# TOWN OF FAIRFAX STAFF REPORT

<b>TO:</b>	Fairfax Planning Commission
<b>DATE:</b>	August 20, 2020
<b>FROM:</b>	Kara Spencer, Assistant Planner
<b>LOCATION:</b>	6 Walsh Lane
<b>PROJECT:</b>	50 percent remodel and two-story addition to single family residence
<b>ACTION:</b>	Hill Area Residential Development, Excavation, Design Review and Tree Removal permits; Application # 20-8
<b>APPLICANT:</b>	Laura Kehrlein, Architect
<b>OWNER:</b>	Irene Pan Panagoulis Survivor's Trust
<b>CEQA STATUS:</b>	Categorically exempt, § 15301(e)(2)(A)

# 6 WALSH LANE

## AGENDA ITEM #2

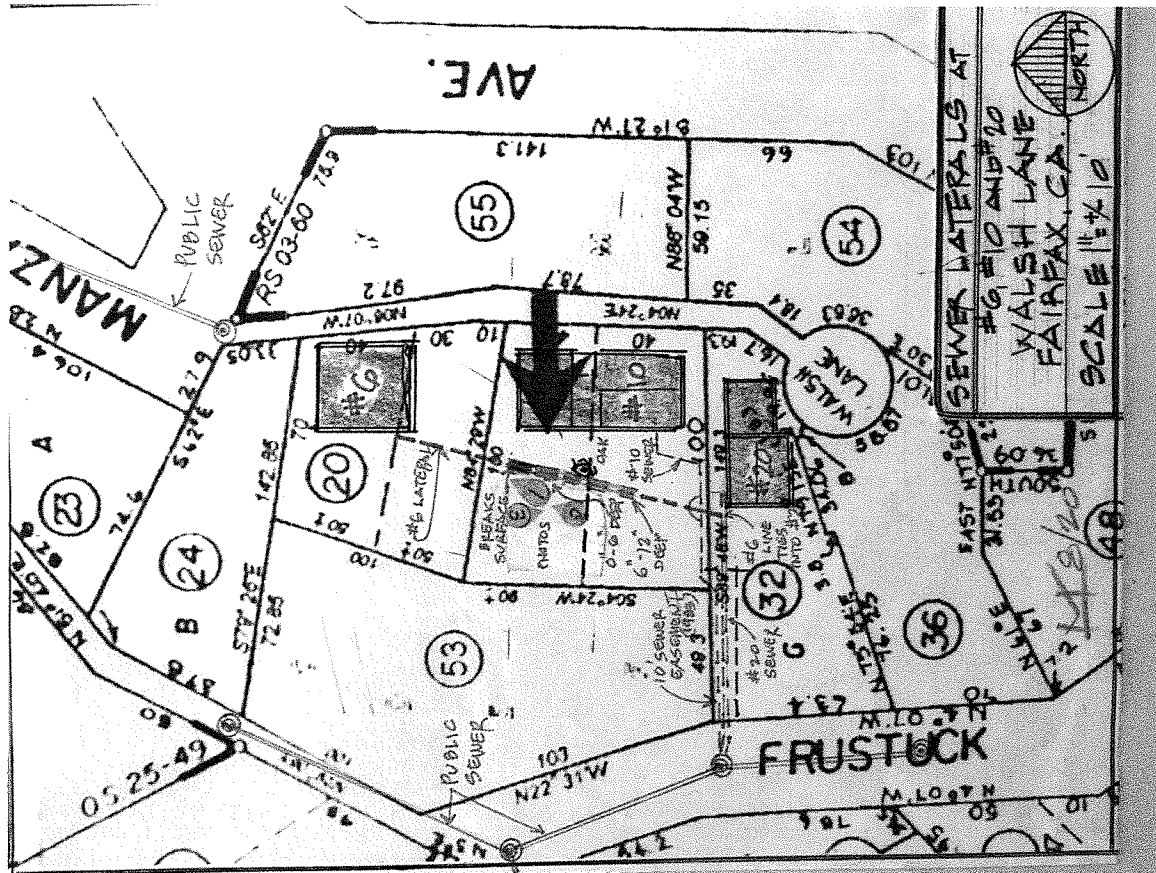
We have suggested to the new owner that the sewer in our rear yard be abandoned and a new one be run out the front of #6 Walsh Lane where a public sewer is about 40 feet away. This appears on the attached sketch. Sharab has offered to help pay for this change. This would simplify things in the long run, especially if there were a failure in the line in her rear yard.

# TREE REMOVAL PLAN

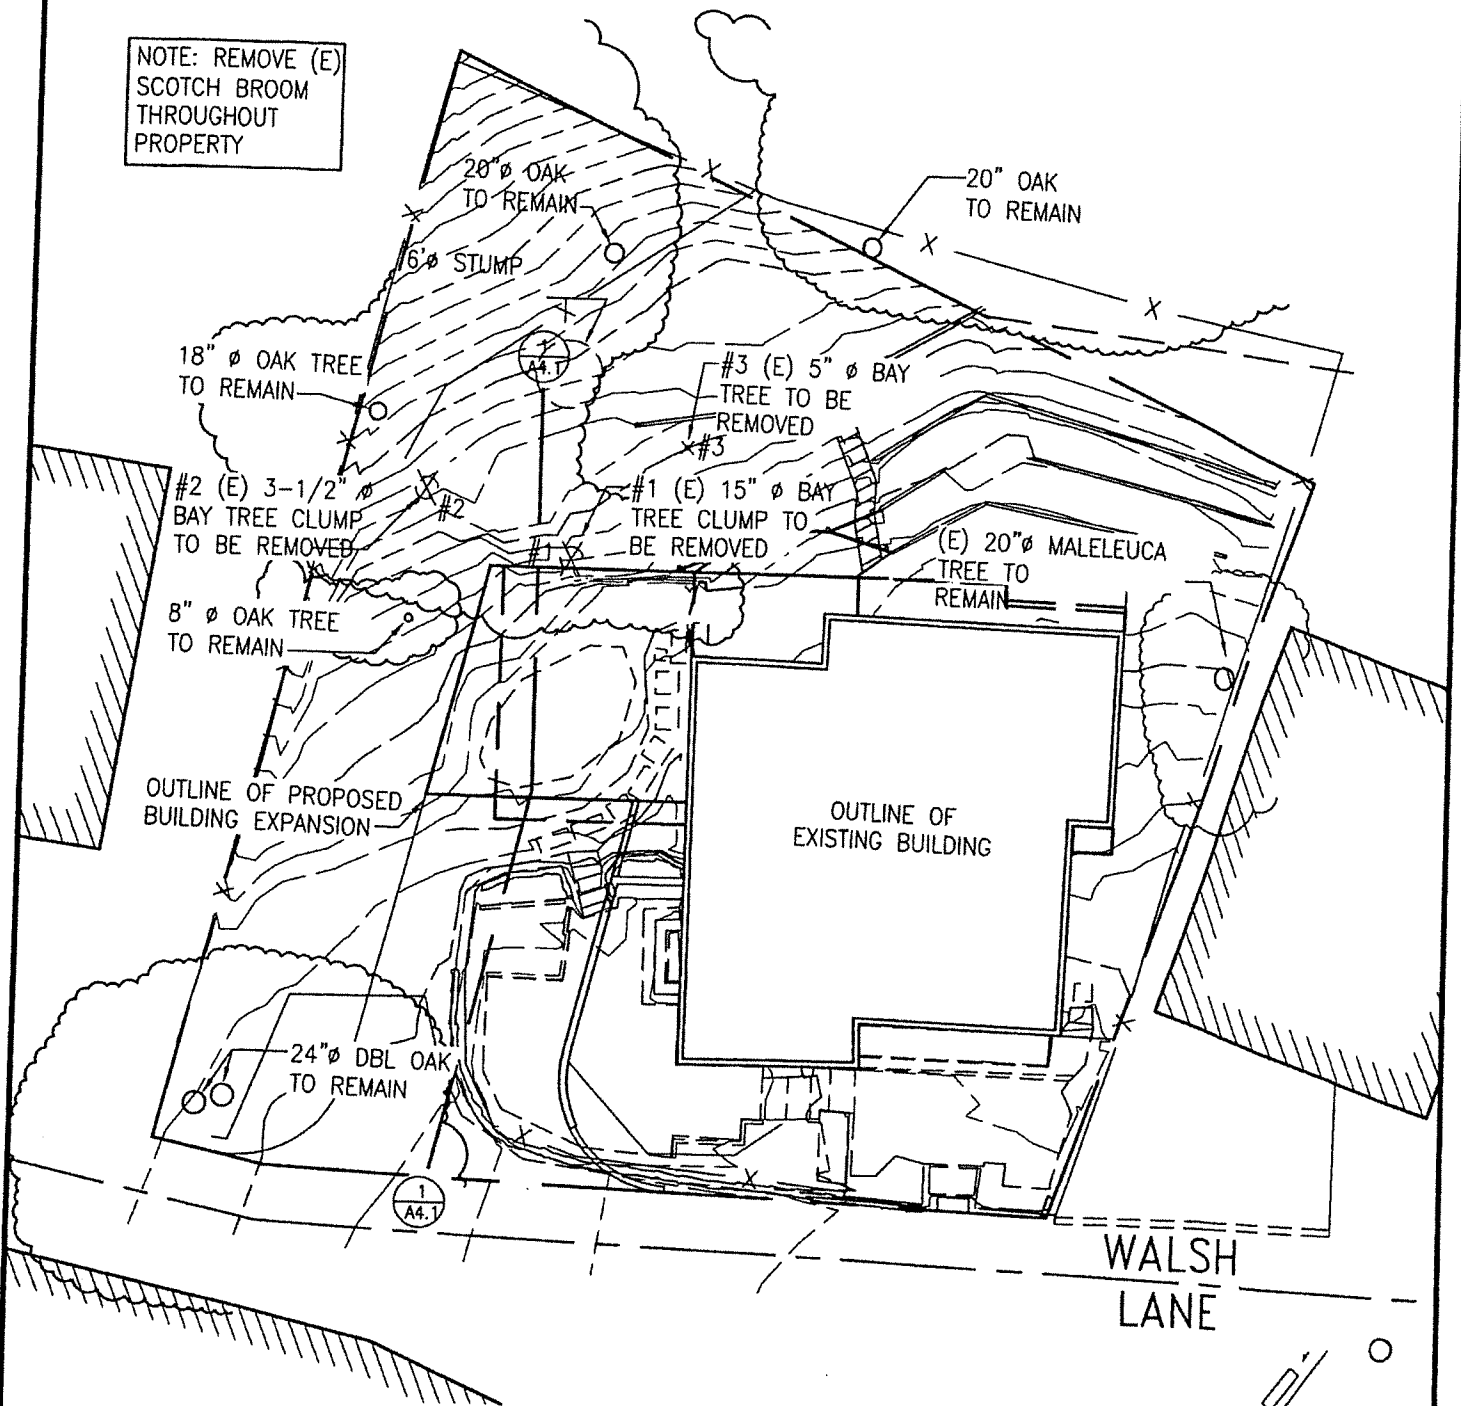
The Vegetation Management Plan submitted for review by the Ross Valley Fire Department is not approved at this time. Please address the following and resubmit:

1. Please provide on the existing plan all the types of vegetation and the crown spacing.
2. For the proposed planting again please identify the crown spacing.
3. Where reference is made to the small Bay Trees to remain, field inspection will determine the potential hazard as these type of trees are highly flammable.

EXISTING PLANTING & TREE CROWNS SHOWN ON DRAWING 1/H.  
CROWNS SHOWN ON DRAWING 2/F1 AND ADDED TO PLANT LIST.  
SMALL BAY TREE NOTE REMOVED

NOTE #4 ADDED TO FIRE DEPT. REQUIREMENTS
